Post Drilling/Annual Well Site Inspection Form

Section 1: General Information	
Operation Data	**Inspection Data**
Operator Name Snake River Oil + Gas, LLC	**Inspector Name** James Thum
Well Name Kauffman #1-34, USWN 11-075-20024	**Area Office** Boise / Director's
Authorized Contact: Dan Johanek (208)800-9503 112 N. Plymouth, New Plymouth ID; Tyler Hartung (208) 412-5475	**Inspection Date** 10/13/2023 12:00 PM
County Payette	**Report Date** 10/30/2023
Inspector's Signature: James Thum **Date of Signature:** 10/30/2023	**Inspection Summary:** ☒ Operation appeared to be in compliance at the time of the inspection. ☒ Issues of concern identified at the time of the inspection.

Constructed trench to prevent pooling snowmelt and runoff, northwest side of pad. View is west.

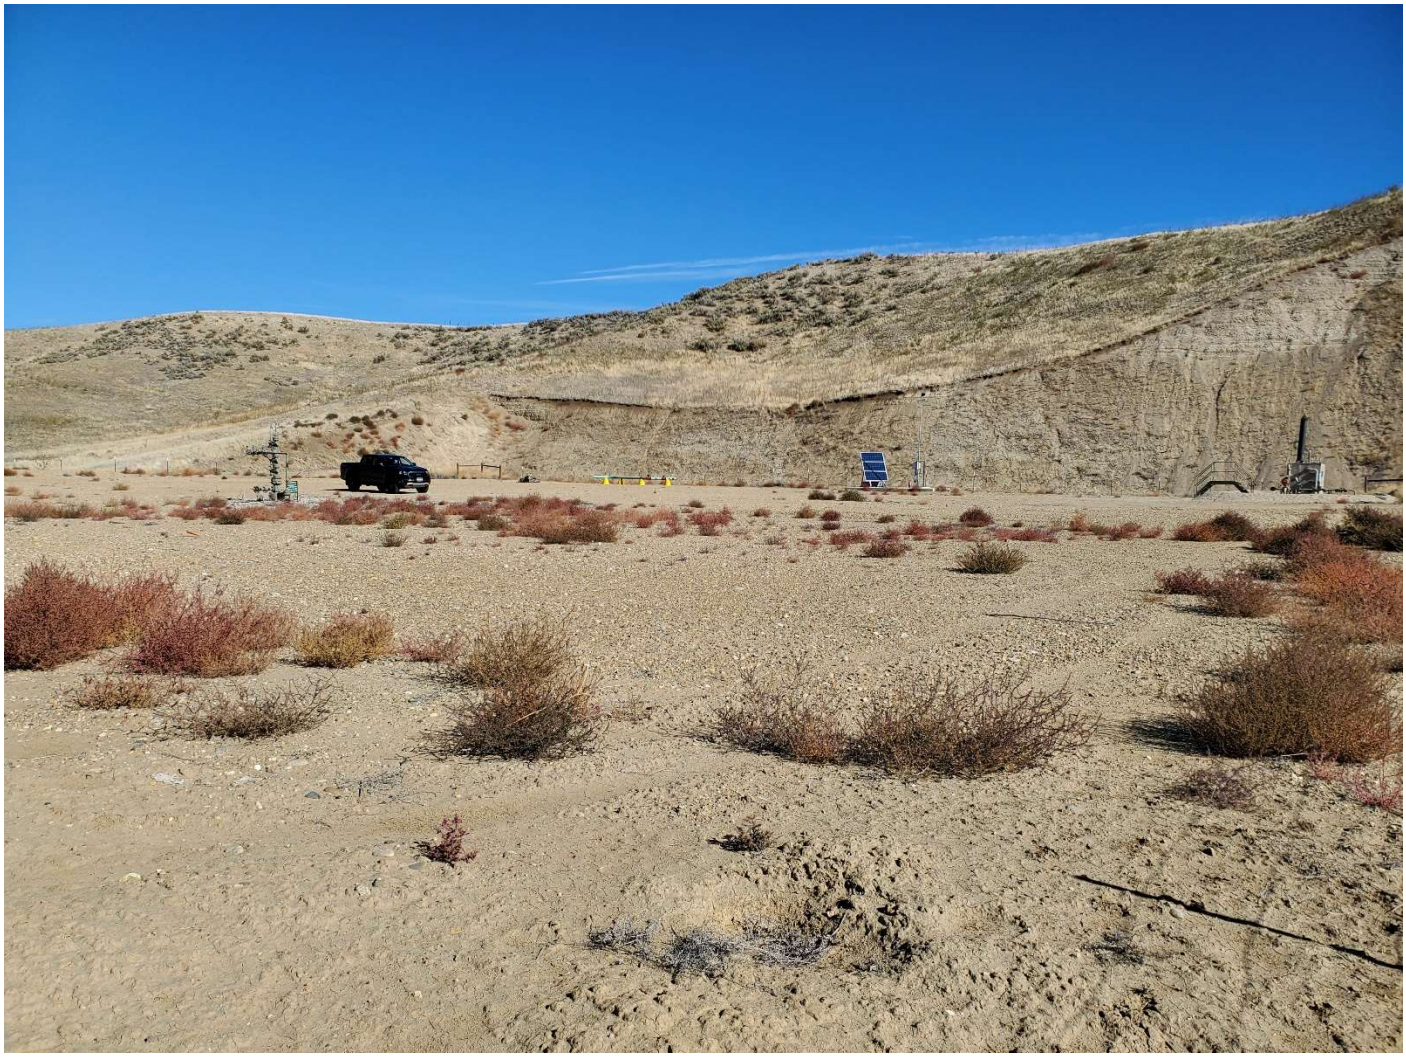
There is a constructed trench and ditch along the northwest side of the well pad, evidently to drain snow melt and spring run-off. This should be corrected.
